**ADDENDUM NO. ONE (1)
CITY OF JEFFERSON, GEORGIA
WEST SIDE LIFT STATION REPLACEMENT
ISSUED MARCH 22, 2023**

EMI PROJECT No. 12-033

FROM: ENGINEERING MANAGEMENT, INC.
303 SWANSON DRIVE
LAWRENCEVILLE, GA 30043
Daniel Patterson, P.E.
770-962-1387

WETWELL "A" & VALVE VAULT
SECTION VIEW
SCALE: 1/4" = 1'-0"

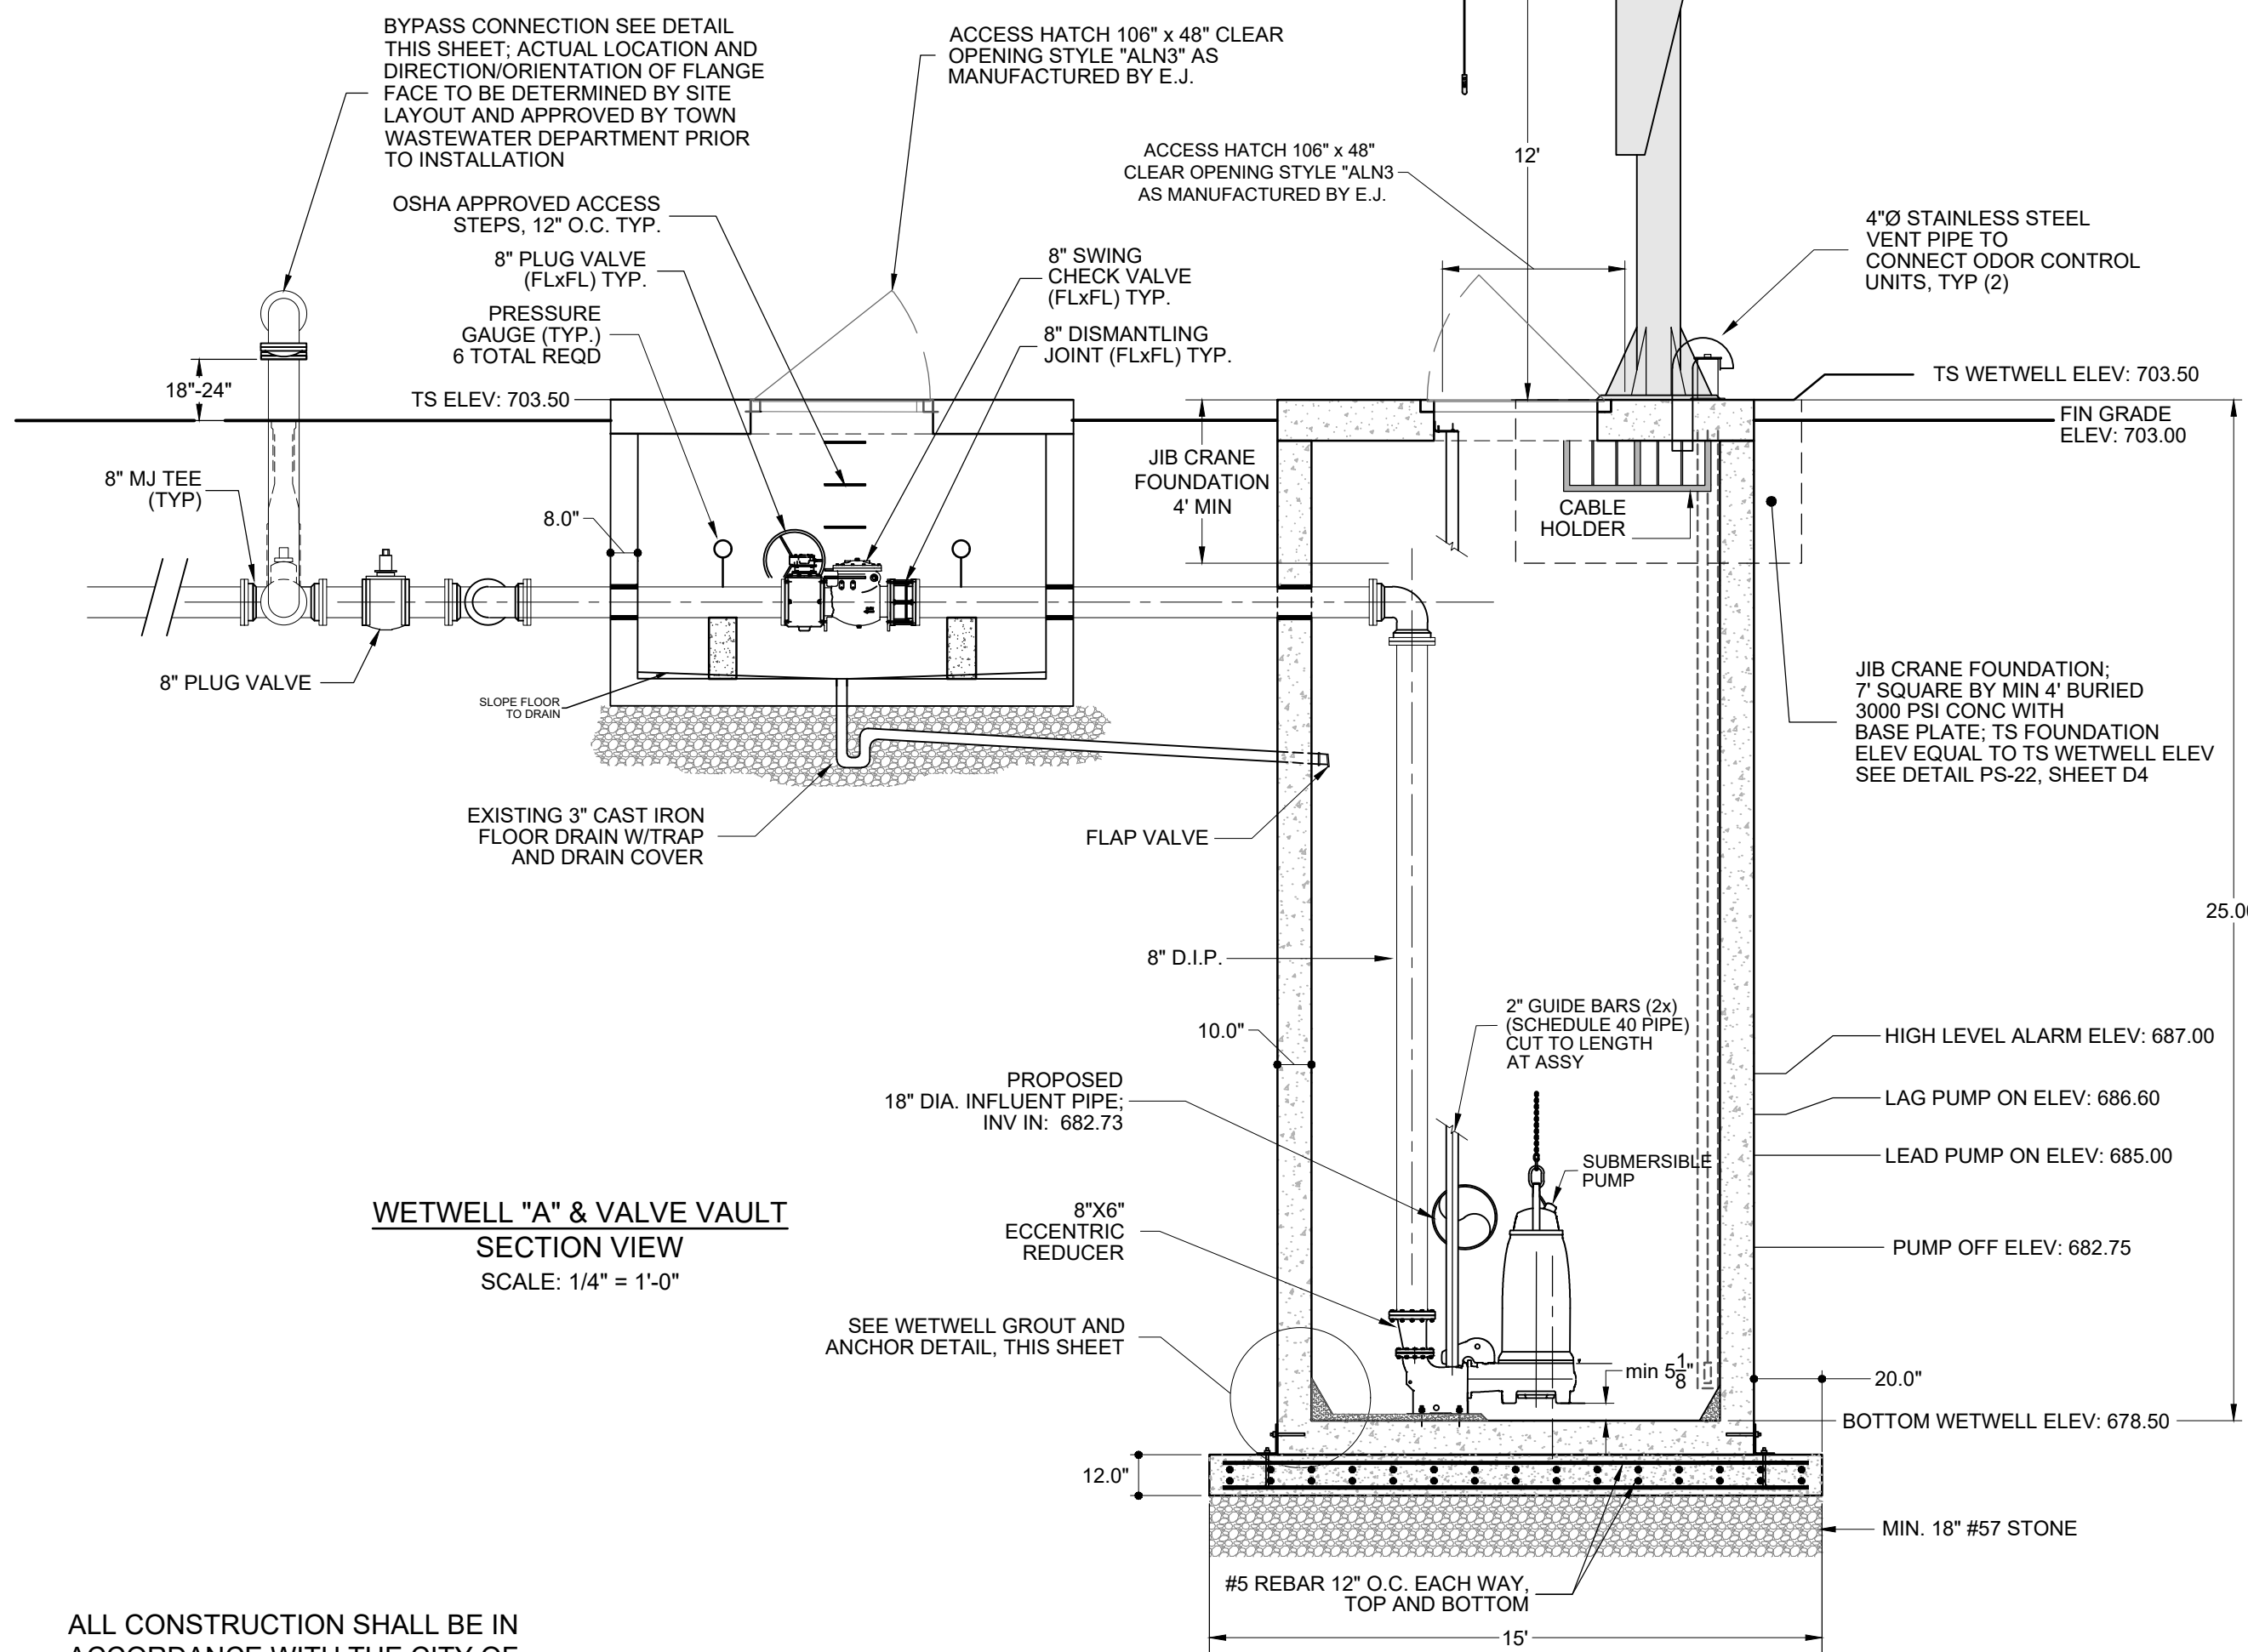
The jib crane detail on the above listed sheet was modified from hoist model “cm lodestar electric chain hoist 460 vac, manual trolley mount, model 3316T983 with 40' lift” to hoist model “cm lodestar electric chain hoist 460 vac, motorized trolley mount, model 3316T987 with 30' lift”

HOIST SHALL BE CM LODESTAR ELECTRIC CHAIN HOIST460 VAC.
MOTORIZED TROLLEY MOUNT, MODEL 3316T987 WITH 30' LIFT
CONTRACTOR SHALL SUBMIT SHOP DRAWINGS OF HOIST AND CRANE TO
DESIGN ENGINEER FOR APPROVAL PRIOR TO INSTALLATION
